Fuel Tee Leak

Title	17KWA: Fuel Tee Leak
Search Words	Fuel, tee, leak, recall
Bulletin No.	17KWA
What's New Abstract	Safety Recall - Fuel Tee Leaking on Models K370, T680, and T880 2017 emissions vehicles.
Supplier	VOSS
Description	Fuel Tee Leaking on Models K370, T680, and T880 2017 emissions vehicles
Release Date	03/31/2017
Introduction	Kenworth Truck Company has decided that a defect, which relates to motor vehicle safety, exists in certain model K370, T680, and T880 vehicles manufactured from November 18, 2014 through January 18, 2017.
Situation	The vehicles may have been built with a defective fuel tee fitting that leaks. A manufacturing process control for the fuel tee was out of specification, which may have allowed the part to become porous, allowing a fuel leak during operation.
Resolution	Fuel tees will be replaced on vehicles equipped with suspect fuel tees. Select vehicles require installation of a new bracket. See chassis list below for chassis-specific parts required.

Figure 1 Old bracket on left, new bracket on right

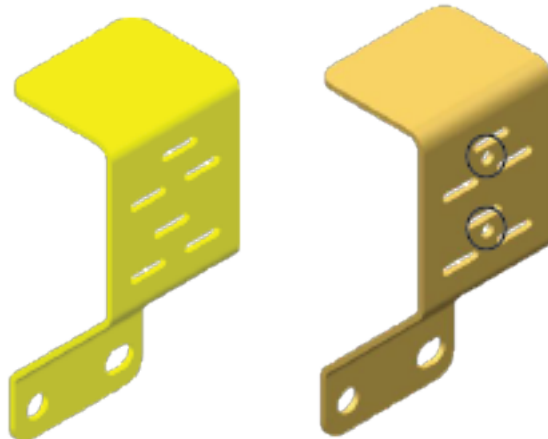
These vehicles require replacement of the mounting bracket, in addition to replacement of the fuel tees. The original bracket does not have holes for the studs on the replacement fuel tees.

NOTE: New fuel tees have a white dot indicator.

1. Install the new fuel tees on the new bracket by aligning the locking tabs and stud to the corresponding slots and hole in the bracket and then pressing the fuel tee firmly into the bracket until the tabs snap into place.
